Vogtle Project

Reference: Vogtle Electric Generating Plant - Units 1 & 2
RII: JPO, 50-424; 50-425 Interim Reports, dated 11/11/80,
4/1/81 and 12/10/81
10CFR50.55(e) (Charging Pumps)

PROPOSED CORRECTIVE ACTION
CENTRIFUGAL CHARGING PUMP MINIFLOW

Figure 1
AUXILIARY MINIFLOW PATH

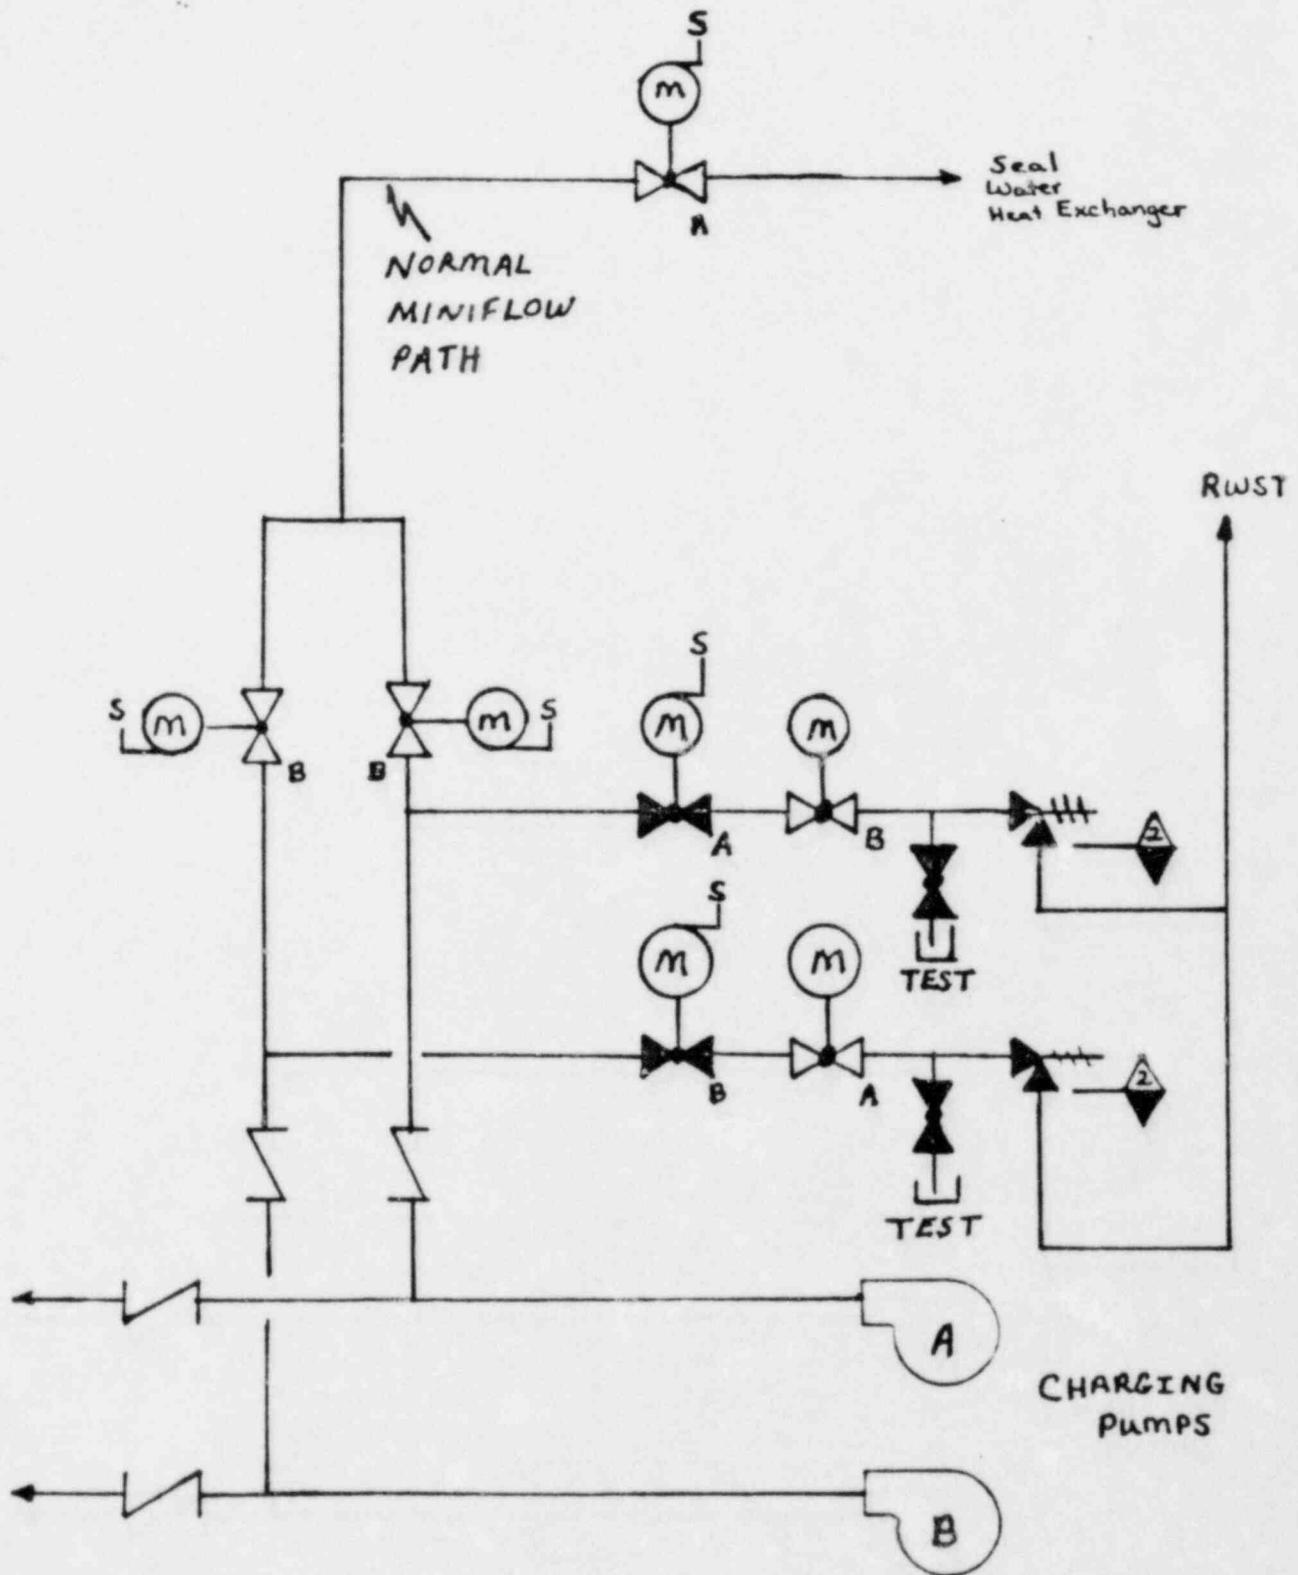
The system modification shown in Figure 1 provides an auxiliary miniflow path which is made available to protect each charging pump whenever a safety injection actuation signal is present and the normal miniflow path is isolated. The auxiliary path is placed in service by automatically opening a motor operated isolation valve in each individual charging pump branch line. The normally closed isolation valve receives power from the same electric power train as the charging pump it is protecting.

A relief valve is provided in each auxiliary miniflow path with a set pressure established to prevent the charging pump from reaching a dead-head condition. The characteristics of the relief valve are such that as the pump discharge pressure is increased above the relief valve set pressure, the flow through the relief valve increases. The capacity of the relief valve is selected to provide at least the required minimum flow of 60 gpm for each charging pump when the injection flow into the RCS is zero.
